ATTACHMENT I

Marked-up Technical Specification Page:

ATTACHMENT 2  
SAFETY EVALUATION

### DETERMINATION OF NO SIGNIFICANT HAZARDS CONSIDERATION

FIGURE 3.2-1  
ALLOWABLE PEAK LINEAR HEAT RATE VS. BURNUP

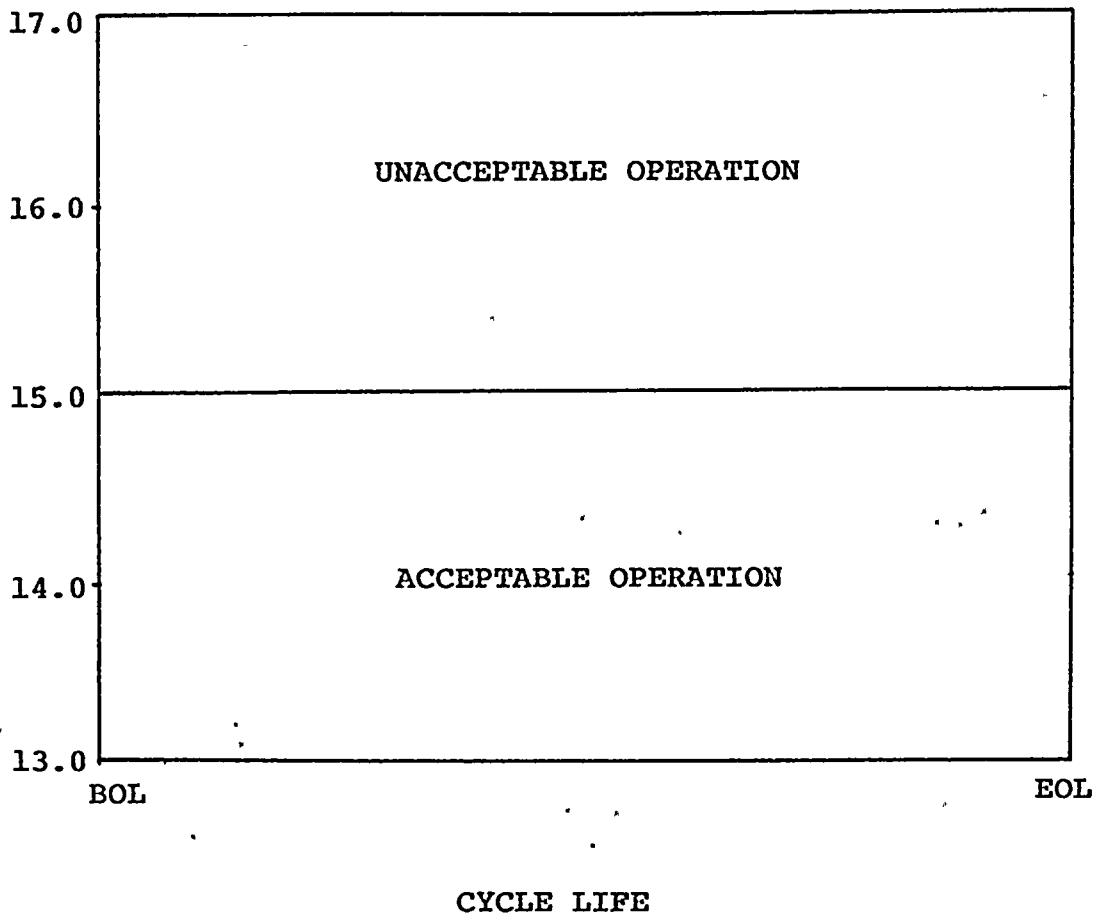
The proposed change to the Linear Heat Rate Limiting Condition for Operation (LHR LCO), Technical Specification 3.2.1, Figure 3.2-1, Allowable Peak Linear Heat Rate vs. Burnup, is to raise the allowable peak linear heat generation rate to 15 kw/ft for all axial elevations for all times in life. The basis for this change is found in Reference 1.

The key changes in the analysis found in Reference 1 from the previous LOCA analysis (Reference 2) are: 1) Steam Generator Tube Plugging limit raised from 11% to 15%, 2) Use of the recently approved FCTF reflood correlations instead of the FLECHT reflood correlations, and 3) Use of less conservative, though still bounding, combinations of stored energy and axial shapes.

The analyses described in Reference 1 have been used to demonstrate that, with a 15 kw/ft LCO on LHR, all criteria are satisfied. A review of these results indicates the following.

- (a) The calculated peak fuel element clad temperature does not exceed the 2200°F limit.
- (b) The amount of fuel element cladding that reacts chemically with water or steam does not exceed 1% of the total amount of zircaloy in the reactor.
- (c) The cladding temperature transient is terminated at a time when the core geometry is still amenable to cooling. The hot fuel rod cladding oxidation limits of 17% are not exceeded during or after quenching.
- (d) The system long term cooling capabilities provided for previous cores remain applicable for ENC fuel.

The Acceptance Criteria as presented in 10 CFR 50.46(b)(1), (b)(2), (b)(3), (b)(4), and (b)(5) are satisfied based on these results.
